Proposed North Elevation - Revised and submitted as Non Material Amendment

Job Title
Shoreham Centre

Drawing Title
Approved and Revised North Elevations

Job No	Drawing No	Rev
5872	203	A

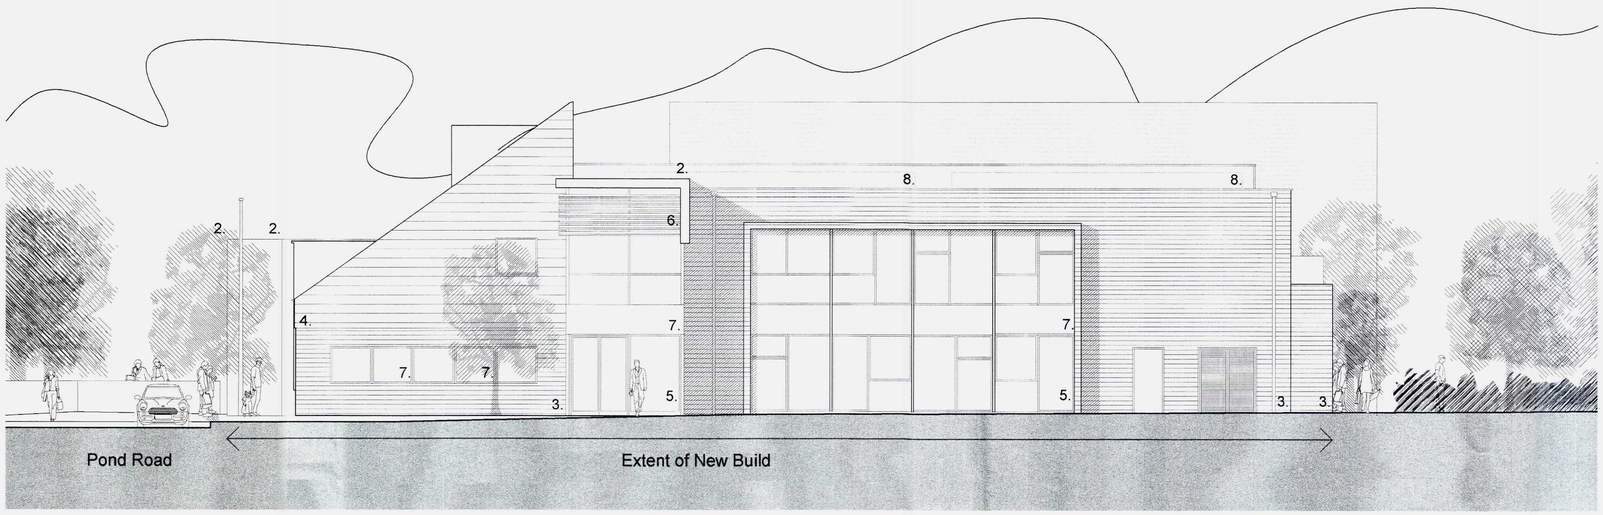
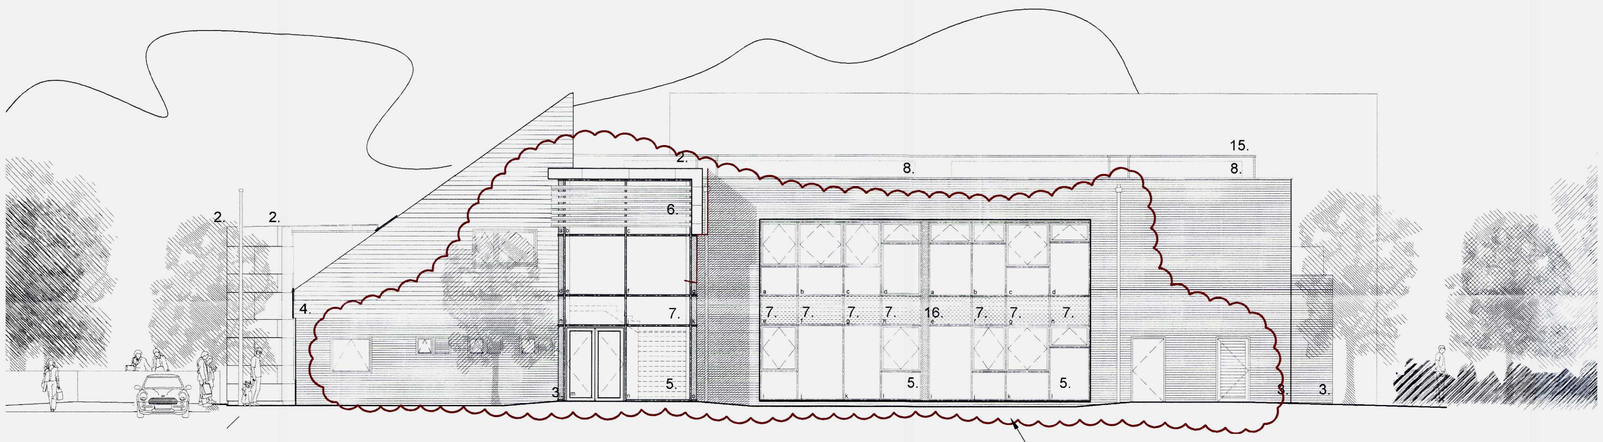
Revised fenestration to North Elevation Curtain Wall; projecting surround to curtain walling removed; rainwater downpipe moved; plant room door changed from double to single; revised fenestration for relalocated toilets and first floor members room (including PPC extract louvres); stairwell curtain walling widened for building control purposes
